March 27, 2008

SUBJECT: COE reply to IDEQ Draft Comments for Pend Oreille River TMDL, Pre-Public Comments

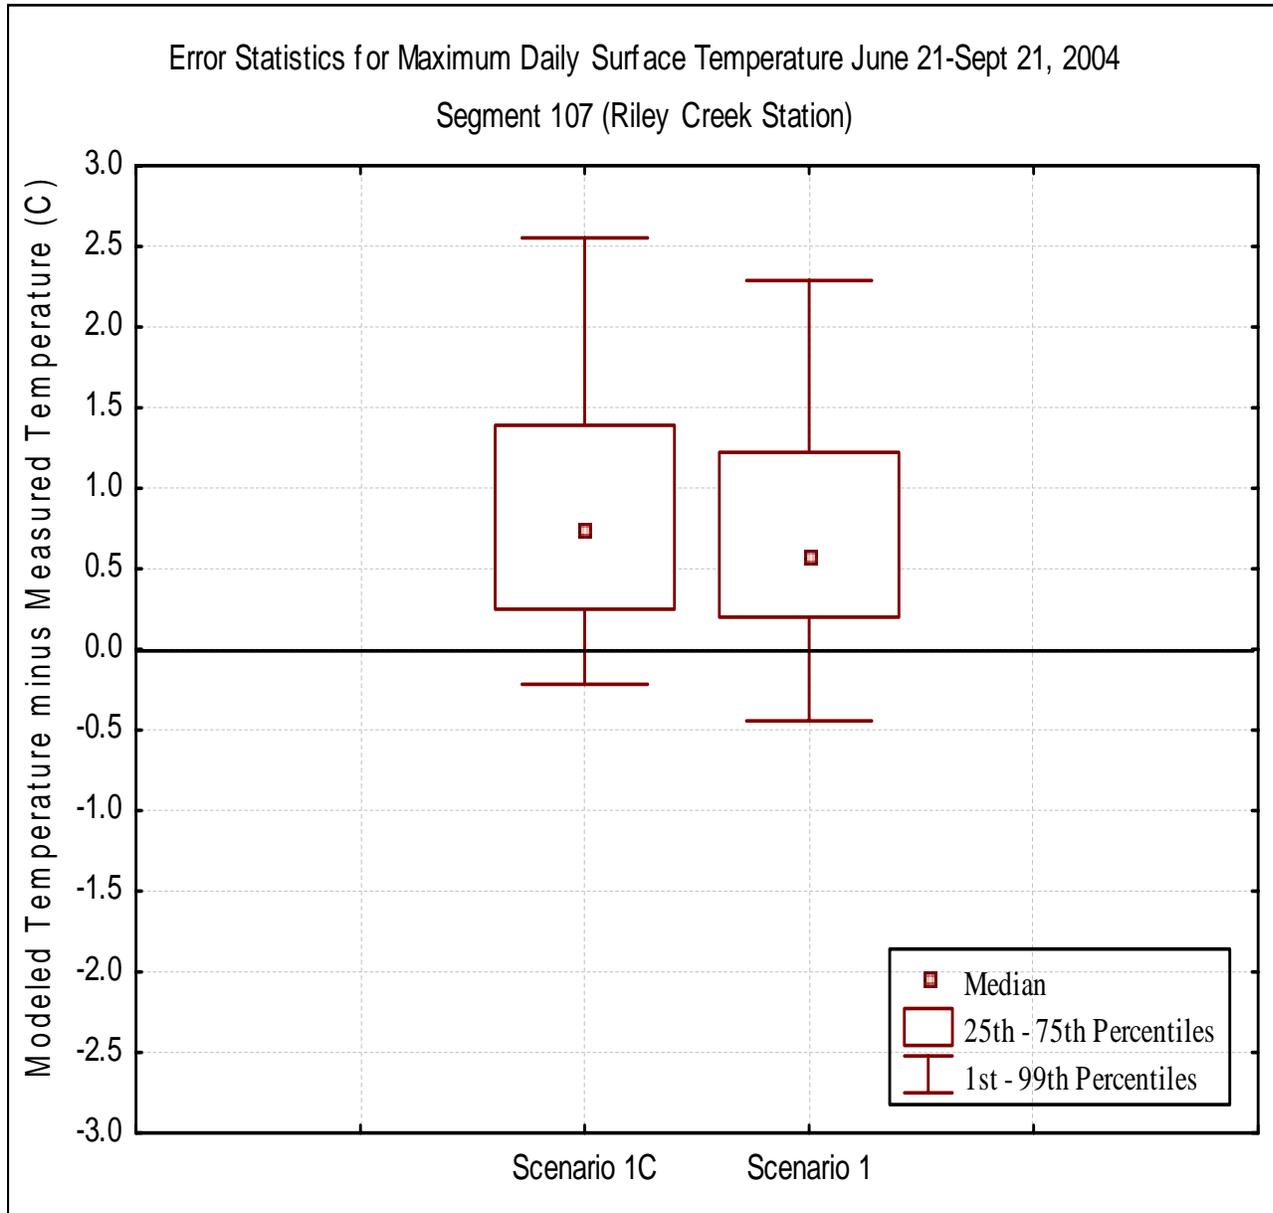
Since the error in hydrology only impacted the July, August, and September time period any calibration data that looked at the entire year for 2004 and 2005 would likely show very little difference. The Seattle District recommends that a recalibration be done because the model continues to have a large positive bias (over predicts temperatures), especially for the surface cells during the critical time period of June 21 to September 21, 2004. The data clearly show that the “existing” scenario surface daily maximum temperatures in July, August and September predicted by the revised model are greater than for the original model (See Figure 1), and that both models over predict surface temperatures for the 2004 season when directly compared to actual temperatures physically measured in 2004 (see Attachment B of the November 9, 2007 Review Comments). Sensitivity analysis on critical input parameters needs to be done by Portland State University to determine why the revised model continues to over predict temperatures during the critical June 21 to September 21 time period. The mean error for the Idaho section of the model near the boundary condition (Segment 7) and at Riley Creek (Segment 107) are considerably greater than any mean error calculated for the Box Canyon and Boundary sections of the model.

The recalibration of the model was deemed unnecessary by the IDEQ contracted modeler. Is the currently calibrated model adequate to identify differences in temperatures at a 0.3 C tolerance at a specific point in space (model cell 1m x 250 m) and time (10 second duration) between two scenarios with and without Albeni Falls Dam at a suitable confidence level? (reference Index AC-2 response).
